NPF-10/15-449

CURRENT TECHNICAL SPECIFICATION IMPROVEMENT PROGRAM
(PCN 299) TECHNICAL SPECIFICATIONS

REVISED TECHNICAL SPECIFICATION IMPROVEMENT PROGRAM
(PCN 299) TECHNICAL SPECIFICATIONS

REVISED TECHNICAL SPECIFICATION IMPROVEMENT PROGRAM
(PCN 299) TECHNICAL SPECIFICATIONS

FIGURE 3.7.18-1

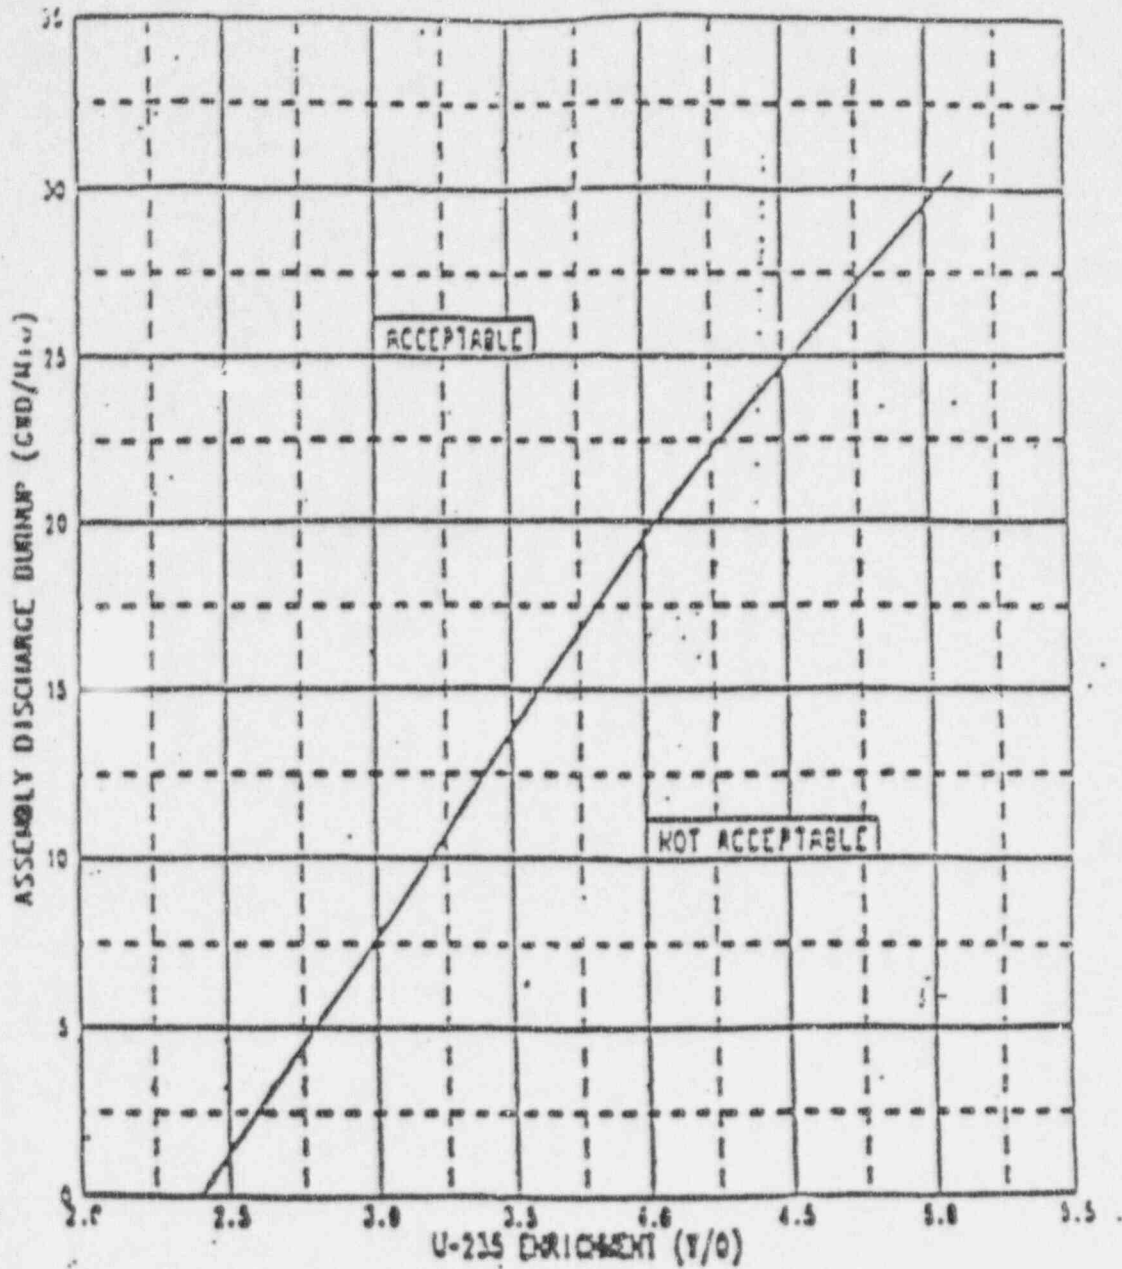
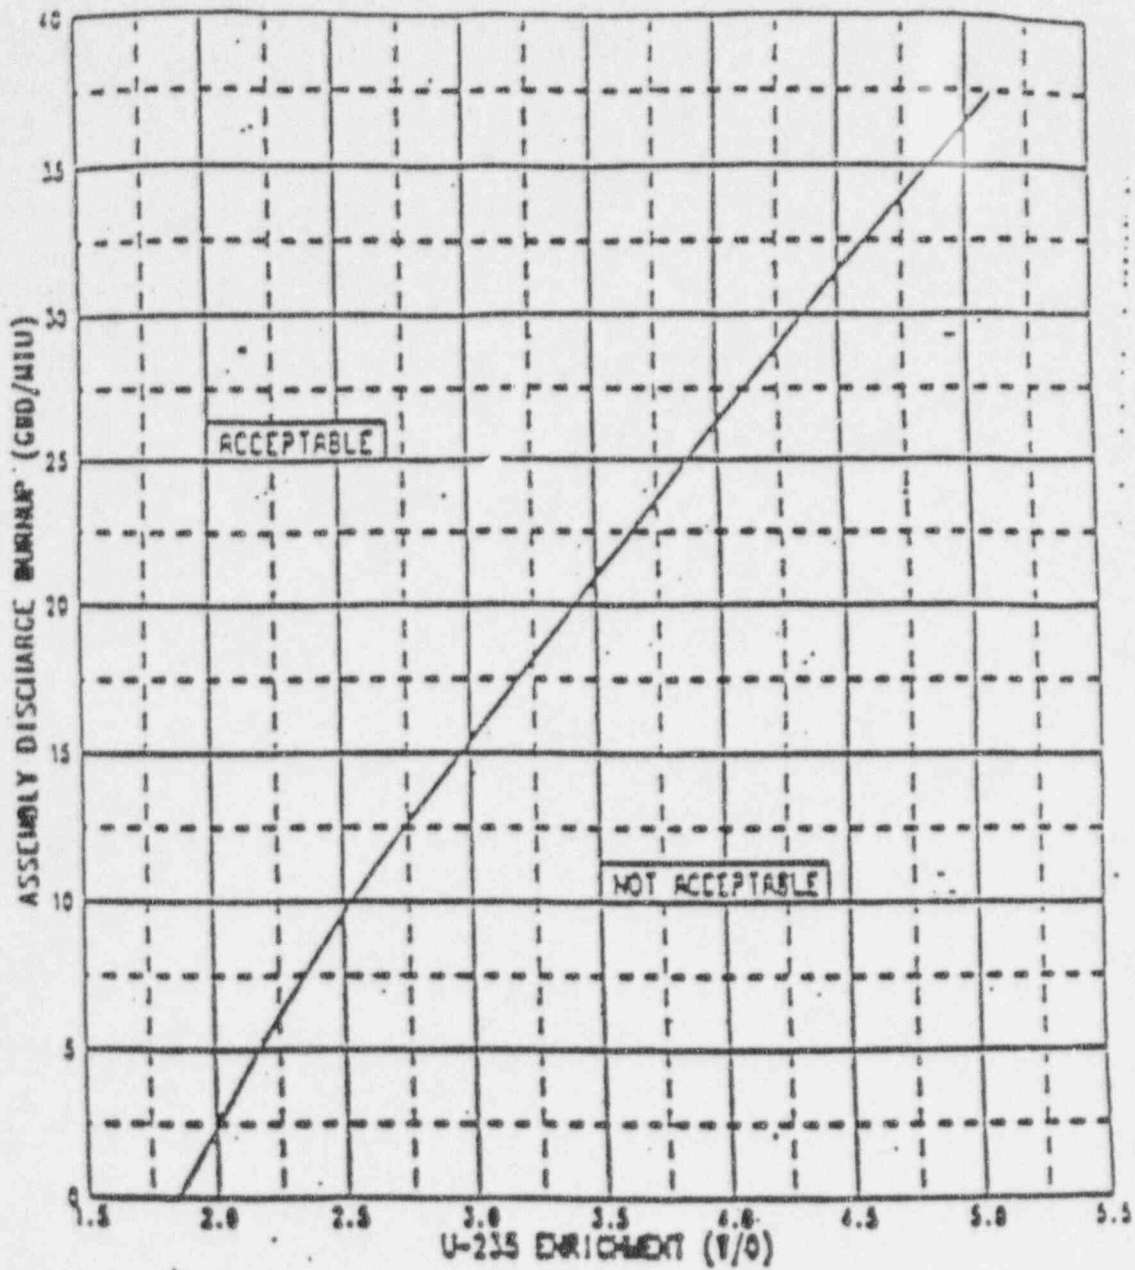
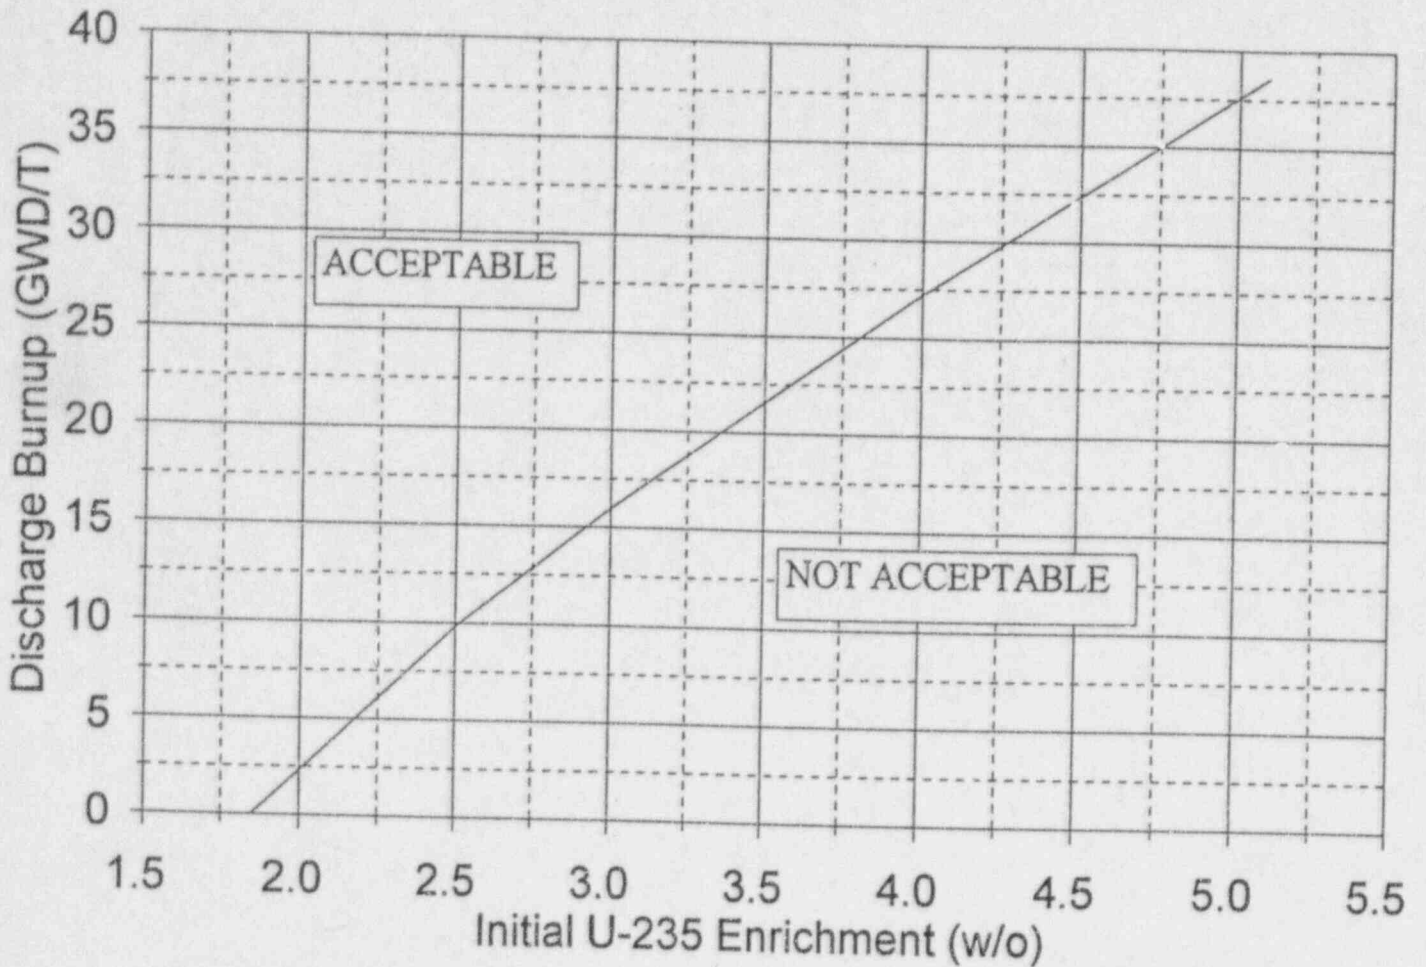
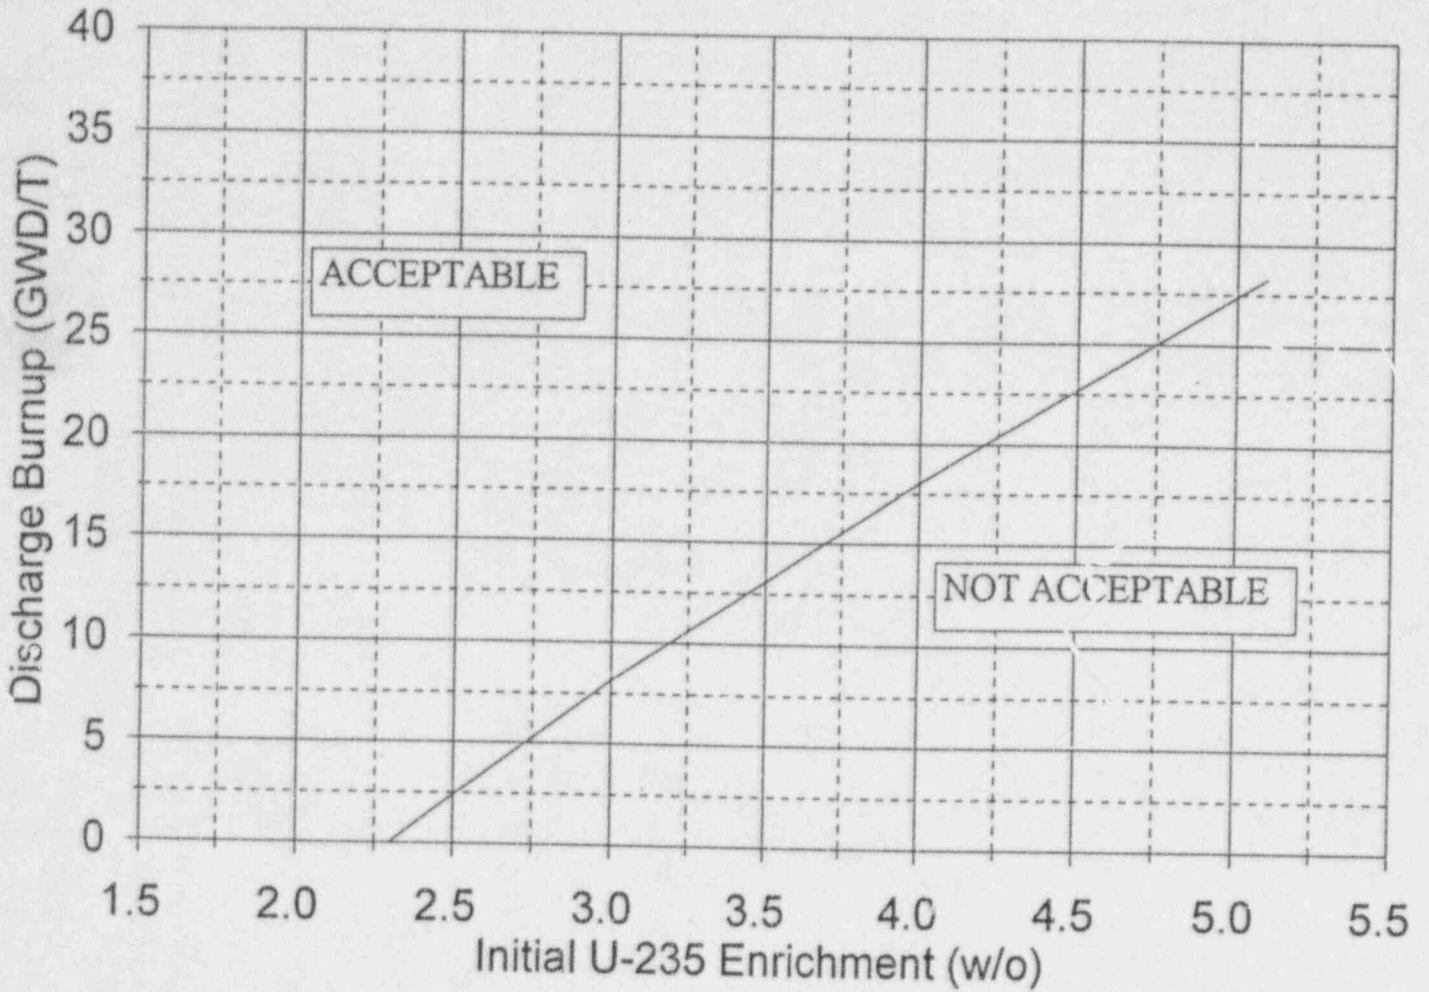
LCO 3.7.18 The combination of initial enrichment and burnup of each SONGS 2 and 3 spent fuel assembly stored in Region II shall be within the acceptable burnup domain of Figure 3.7.18-1 and or Figure 3.7.18-2, or the fuel assembly shall be stored in accordance with Licensee Controlled Specification ~~4.3.1.1~~ 4.0.100.

- e. Units 1, 2, and 3 Fuel assemblies may be stored in Region I with no restrictions;
- f. Units 2 and 3 Fuel assemblies with a burnup in the "acceptable range" of Figure 3.7.18-1 and Figure ~~3.7.18-2~~ are allowed unrestricted storage in Region II; and

MINIMUM BURNUP VS INITIAL ENRICHMENT FOR UNRESTRICTED
PLACEMENT OF SONGS 2 AND 3 FUEL IN REGION II RACKS

- g. Units 2 and 3 Fuel assemblies with a burnup in the "acceptable range" of Figure 3.7.18-2 are allowed unrestricted storage in the peripheral pool locations with 1 or 2 faces toward the spent fuel pool walls of Region II;

- h. Fuel assemblies with a burnup in the "unacceptable range" of Figure 3.7.18-1 ~~or and~~ Figure 3.7.18-2 will be stored in compliance with the Licensee Controlled Specification 4.0.100; and

MINIMUM BURNUP VS INITIAL ENRICHMENT FOR PLACEMENT
OF SONGS 2 AND 3 FUEL IN REGION II PERIPHERAL POOL LOCATIONS
